Addendum #5 - Issued on January 2, 2013

ADDENDUM NO. 005

**Renovations to Buildings B, C and D
At the McCord Road Complex**

ADDENDUM NO. 005
Renovations to Buildings B, C and D
Lucas County Board of Commissioners

SHEET NO.
 E3.01

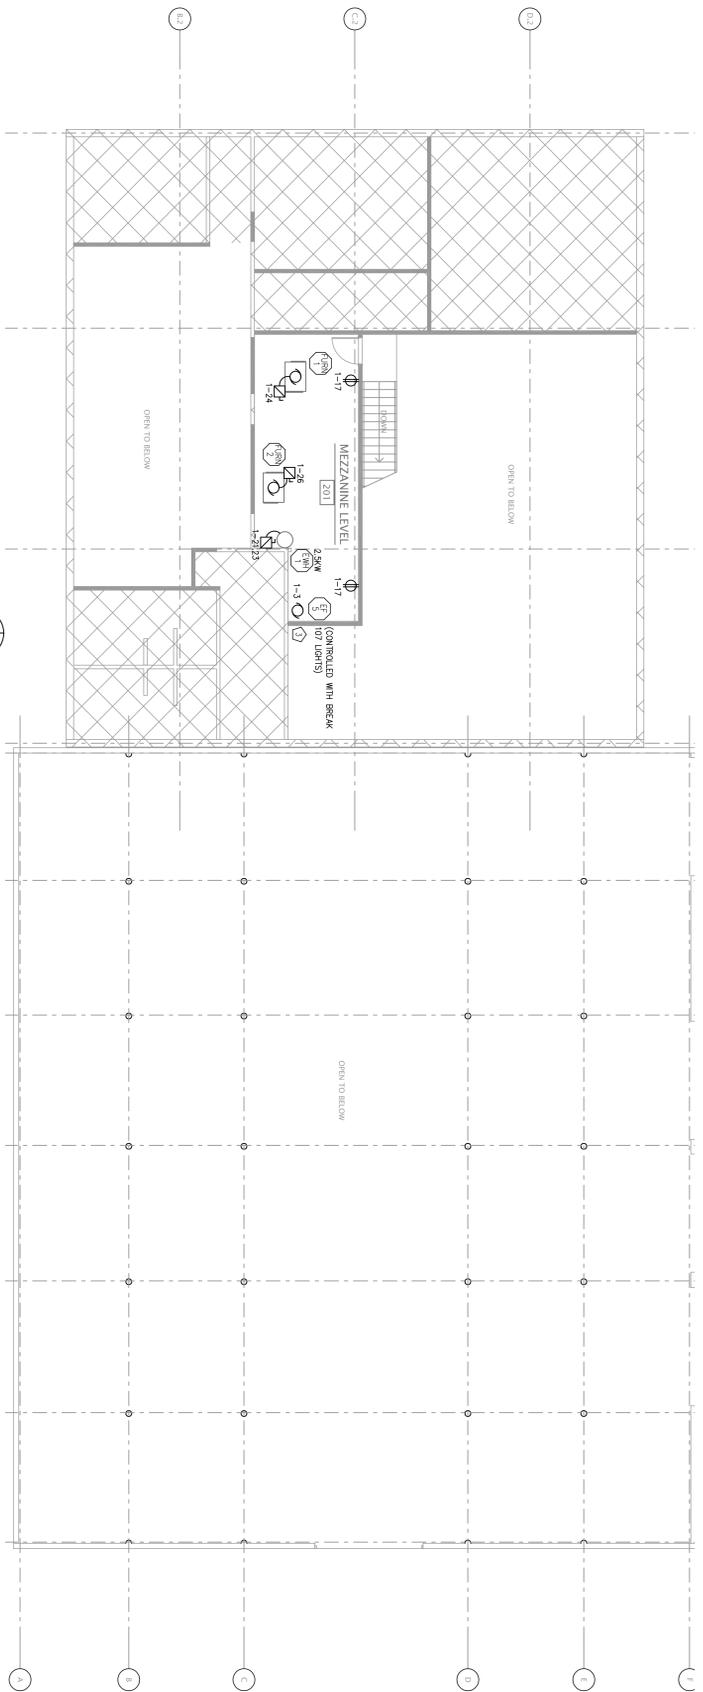
E3.01 – Floor Plans - Electrical (re-issued)

Item #1: New power to added overhead doors in Storage Building C. See re-issued drawing for additional details.

Item #1: 20 Amp – 1 Pole breakers added (6 total) to MDP panel circuits 19, 21, 23, 25, 27, 29 to correspond with new overhead door power requirements. See reissued sheet E3.01 for circuiting details.
